Re: Turkey Point Units 3 and 4
Docket Nos. 50-250 and 50-251
Editorial Corrections to the 2002 Annual Radiological Environmental Operating Report

SUMMMARY OF EDITORIAL CORRECTIONS to L-2003-112

DISTANT REMP SAMPLING LOCATIONS

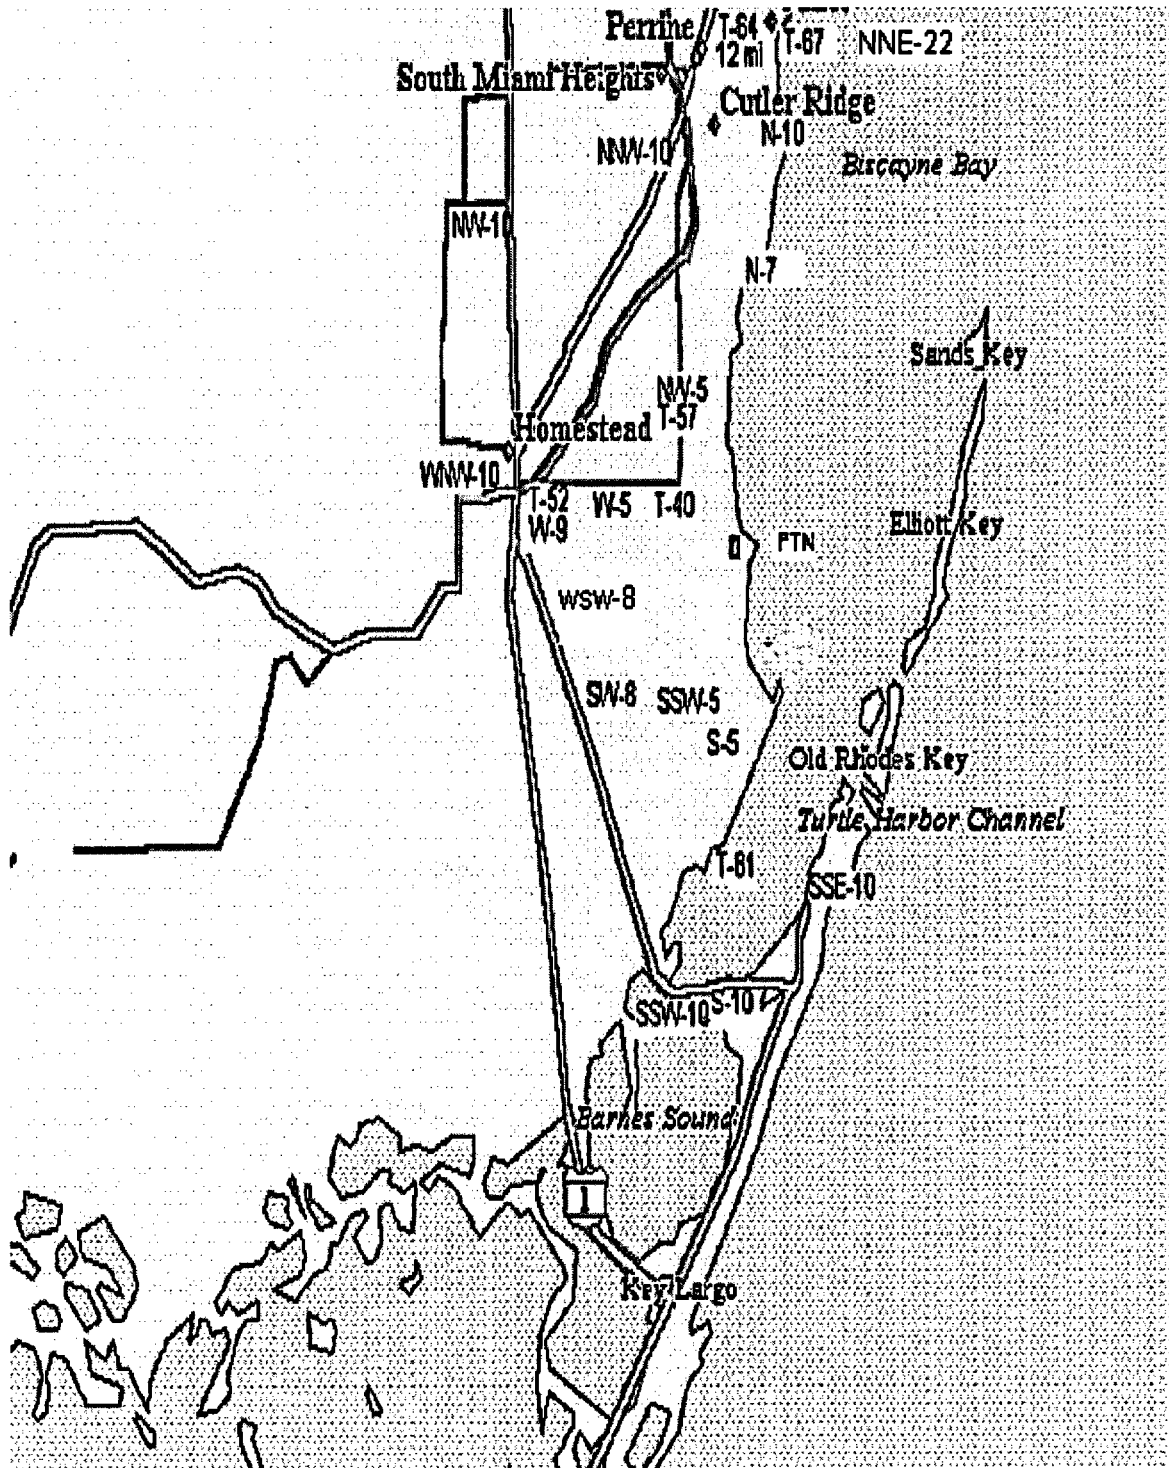
- TABLE 1, Page 6 of 8: The correct value for isotope ⁴⁰K “Control Locations Mean (f)^b Range” is 3068(2/2) instead of 3608(2/2).
- TABLE 1, Page 7 of 8: The correct value for isotope ⁴⁰K “All Indicator Locations Mean (f) Range” is 3722(24/24) instead of 722(24/24).
- TABLE 1A, Pages 1 of 2 and 2 of 2: The year of the indicated “Dates” for each Pathway for sections A through D is 02 instead of 03.
- ATTACHMENT A, KEY TO SAMPLE LOCATIONS: Distant REMP Sampling Location: This Map was changed to indicate the correct PTN location and to show locations NNE-22, and WSW-8.
- ATTACHMENT A, KEY TO SAMPLE LOCATIONS: The address for Natoma Substation is added in Page 1 of 4.
